Addendum No. 1
September 6, 2022

Project: **First Lutheran Church Improvements**
327 S Dakota Avenue
Sioux Falls, South Dakota 57104
Project #2843

Architect: Architecture Incorporated

4.20

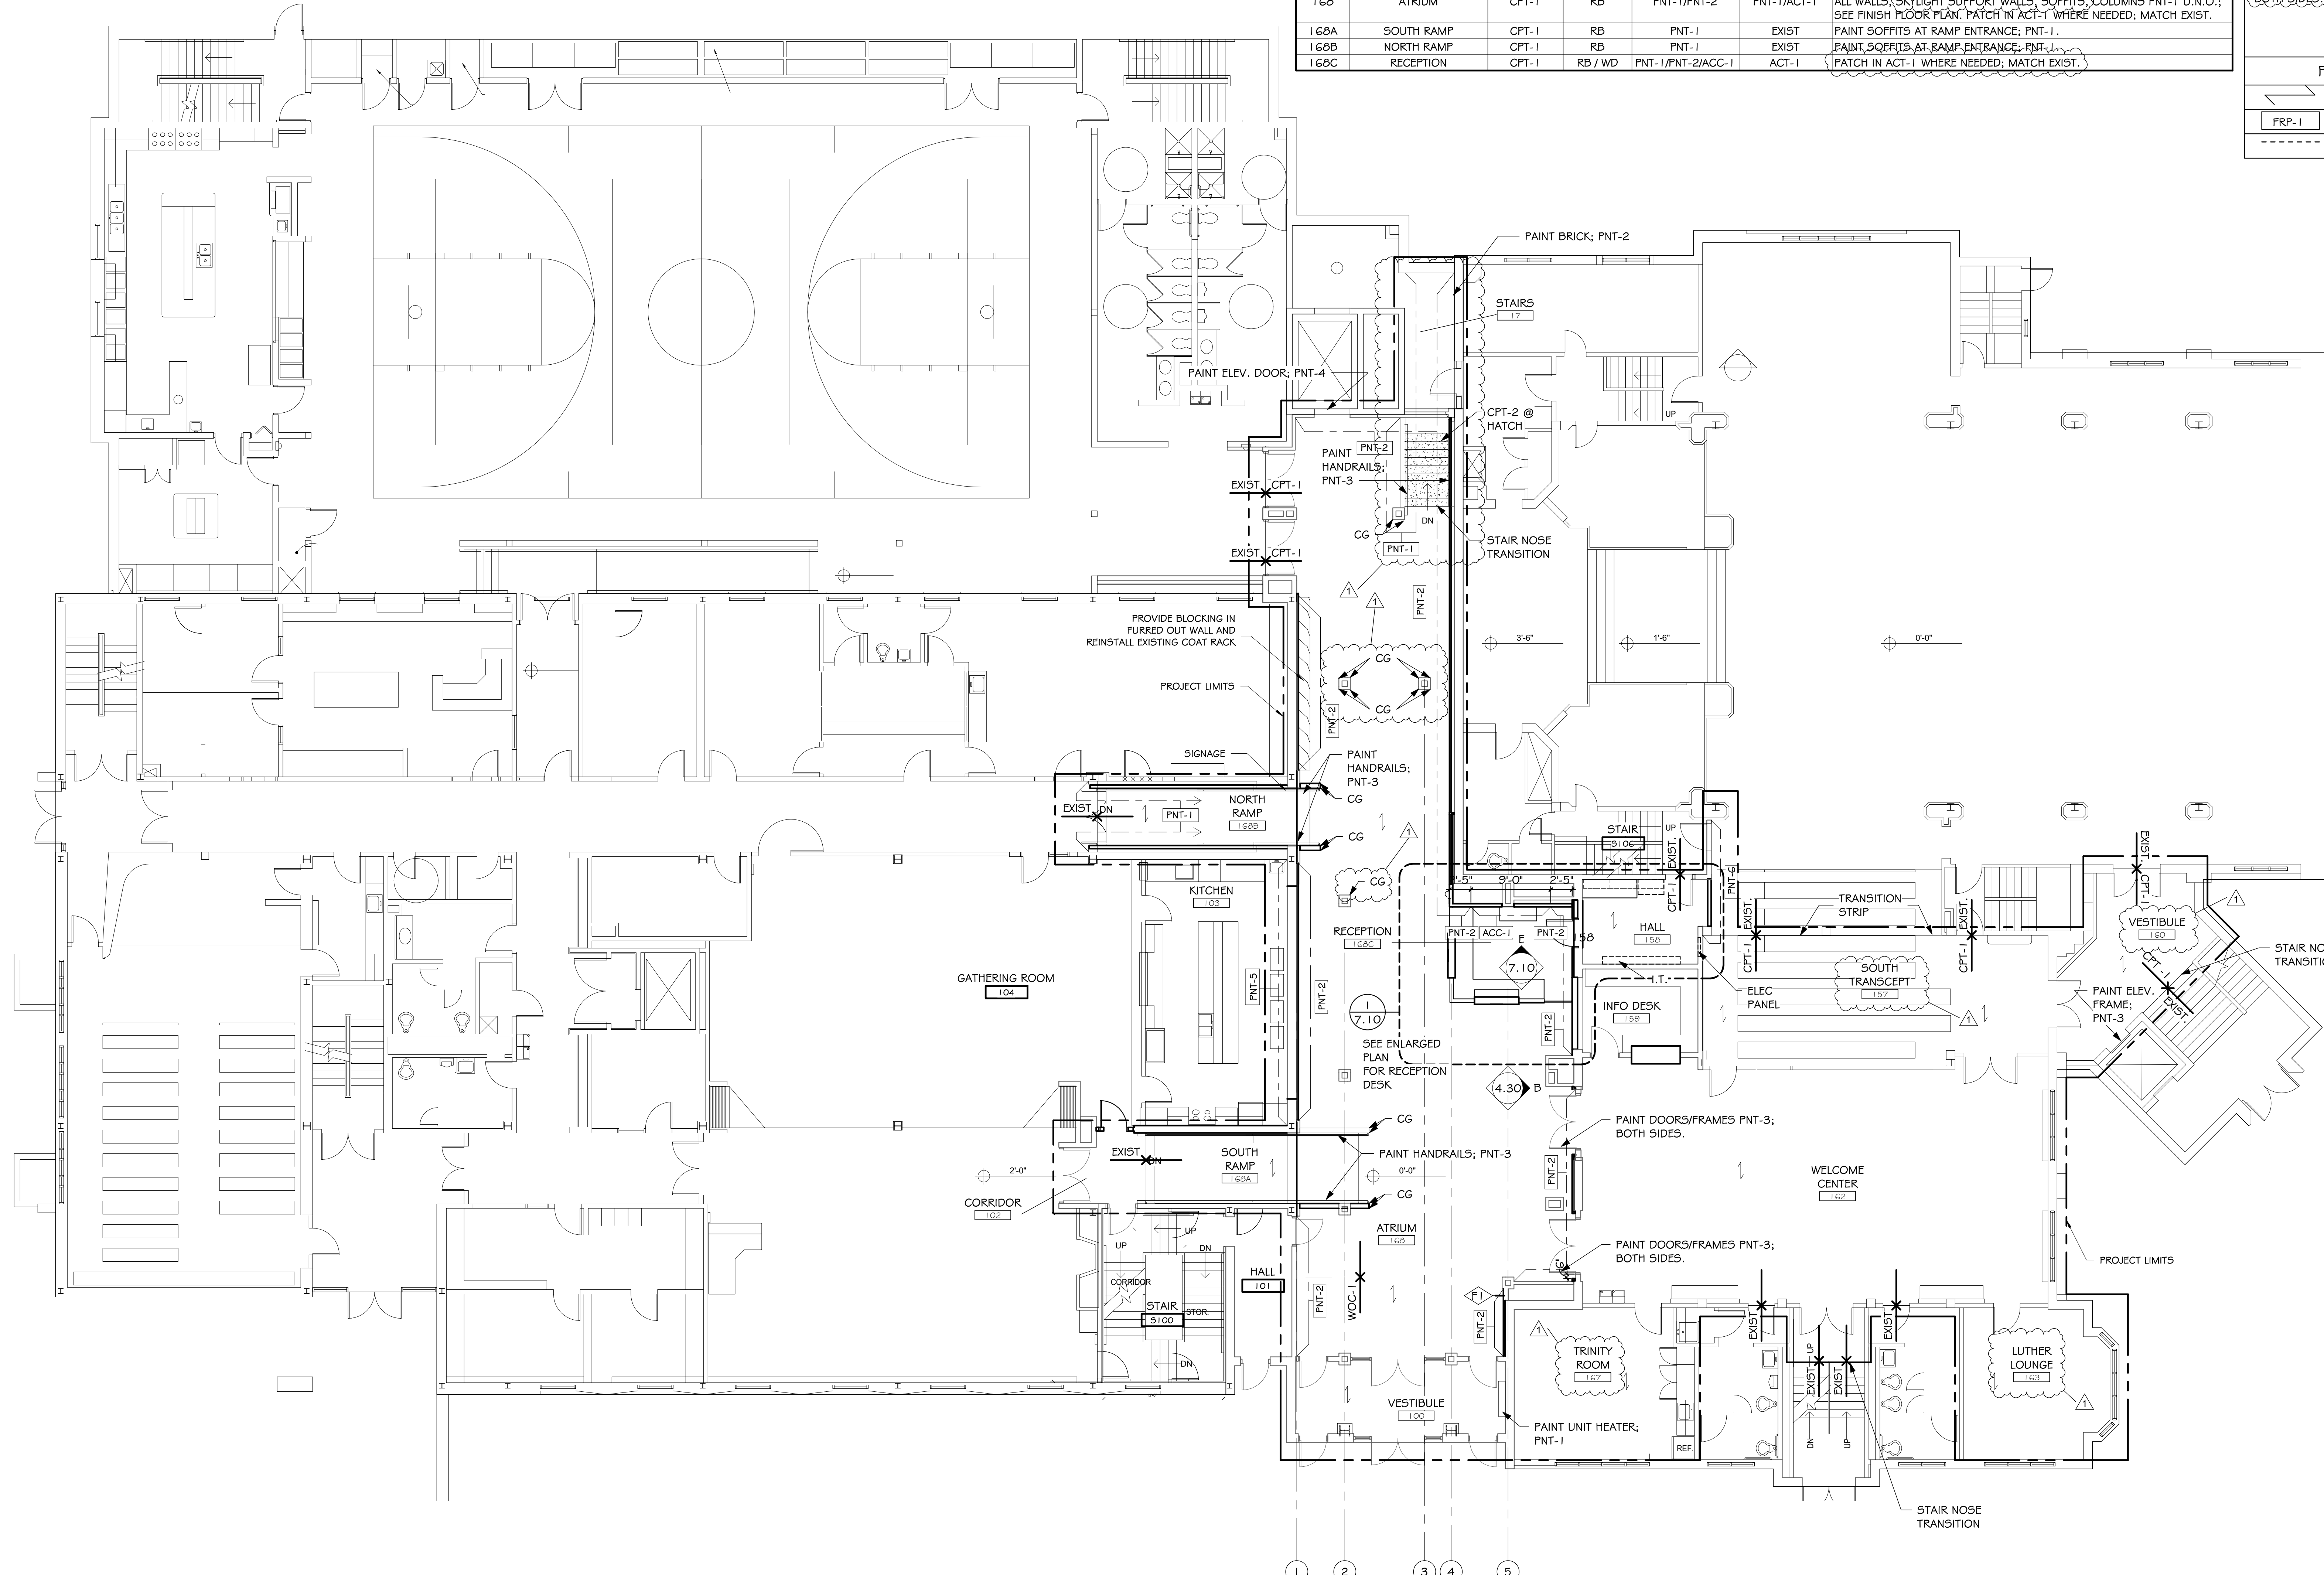
- a) Refer to revised drawing sheet attached to the end of this addendum:
 - i) Add the following room names: South Transcept 157 and Vestibule 160 to match Sheet 4.10.

- ii) Luther Lounge to be Room #163 and Trinity Room to be Room #167.
 - iii) Refer to Sheet 4.20 to clarify paint locations at Stair 17. Note: Paint brick wall at Stairs 17 lower landing PNT-2.

- iv) Note F. in General Notes – Finish Plan to read: “Paint all hollow metal frames within scope of project PNT-3; *both sides.*”
 - v) Room Finish Schedule:

- (1) Floor Finish at Stairs 17 to be CPT-2/Exist.
 - (2) Wall finish at Room 159 Info Desk to be EXIST.
 - (3) Add Room 160 Vestibule to Room Finish Schedule. Floor Finish: CPT-1; Base: RB-1; Wall Finish – EXIST; Ceiling Finish – EXIST.

- (4) Add the following Note at Room 168C Reception: “Patch in ACT-1 where needed; match exist.”
 - (5) Update the following room numbers: Trinity Room #: 167 and Luther Lounge #: 163

- vi) Additional corner guards have been noted on the plan.
